ACME (Aerospace Contamination Museum of Education) Comments - Historical Site Assessment(HSA)5D, April 18, 2011

Enclosed in this correspondence are comments on the Technical Memo of Sub-Area HSA-5D (Historical Site Assessment) Santa Susana Field Laboratory (SSFL) Site AREA IV Radiological Study - Ventura County, California prepared for the United States Environmental Protection Agency (EPA) Contract Number EP-S7-05-05 prepared by HydroGeoLogic, Inc. (HGL).

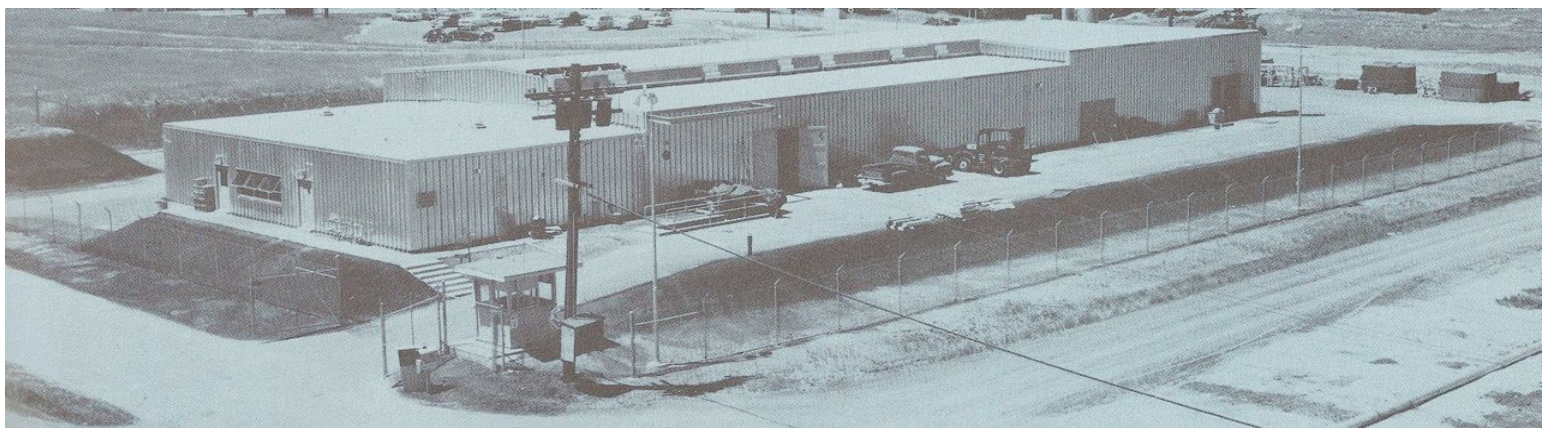
In Section 2.1.1 of the HSA 5D (Parking Lot 4509 AREA - Shown Above Far Left) please note that for the past several years there have been Baker Tanks staged on this platform to collect tainted stormwater runoff that could impact this area and the areas around. I have spoken with a former employee who alleges cleaning of sodium contaminated items on this lot. Click on the link below to read the Rockwell Unusual Occurrence Report regarding Building 4009 that connects to this parking lot. Has HGL or EPA asked The Boeing Co. for these reports or are they unaware of these reports? These reports could help in the remainder of the HSA groupings.

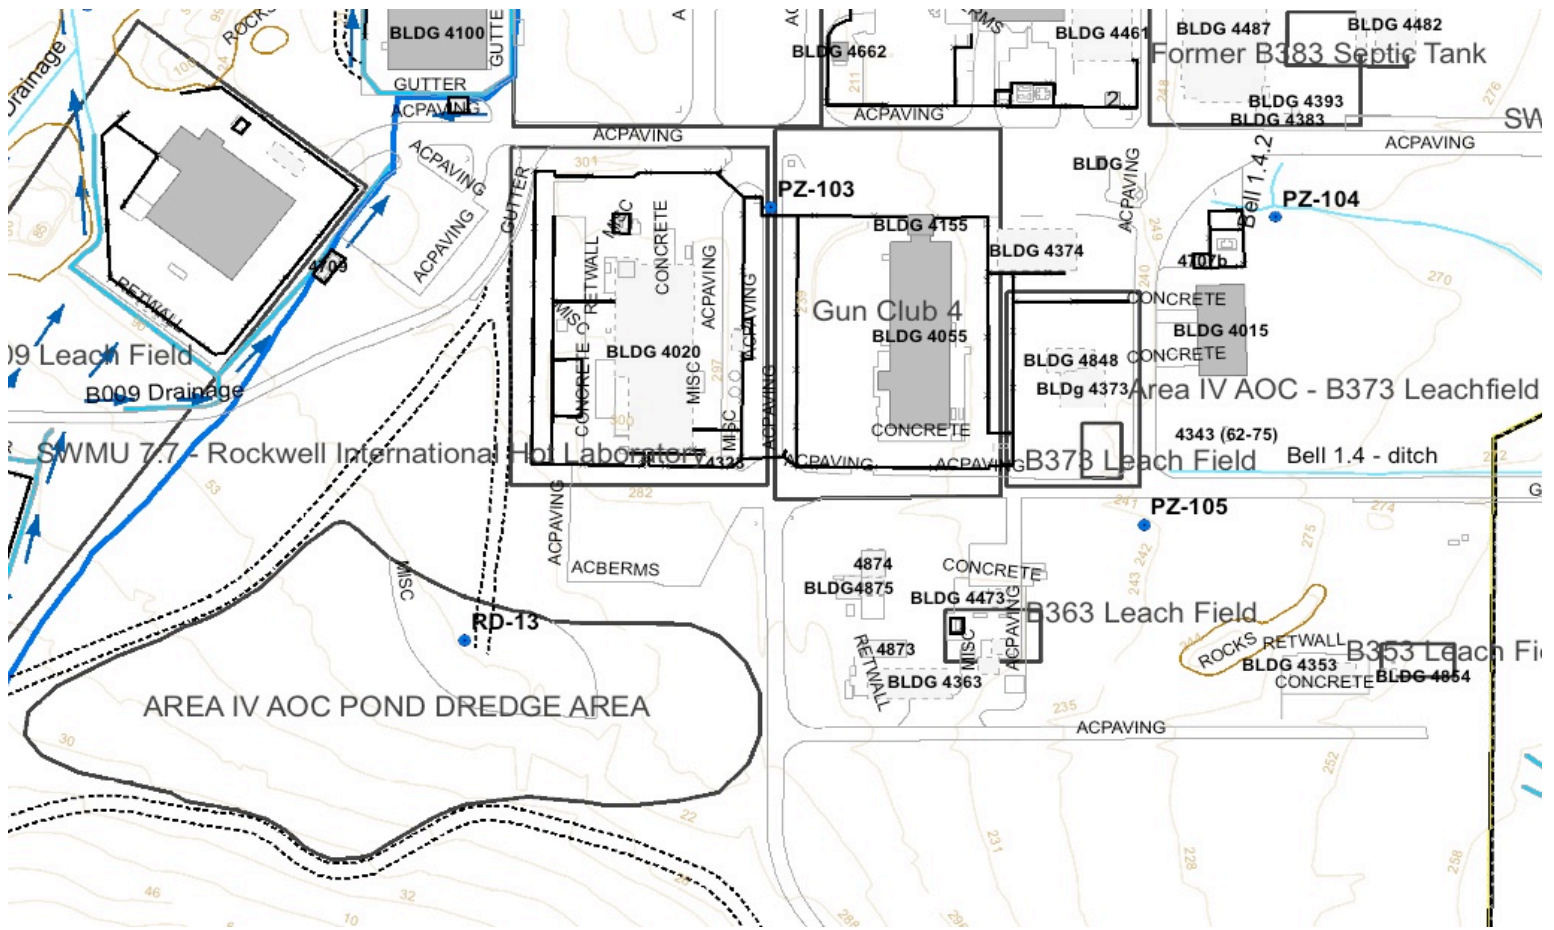
Please note the mounded material in the above and below photos, investigation is needed. Also note in the below photo the location of the yellow "Casks" or "Coffins" that are storing radioactive waste on the West end of the RIHL, please investigate as well.
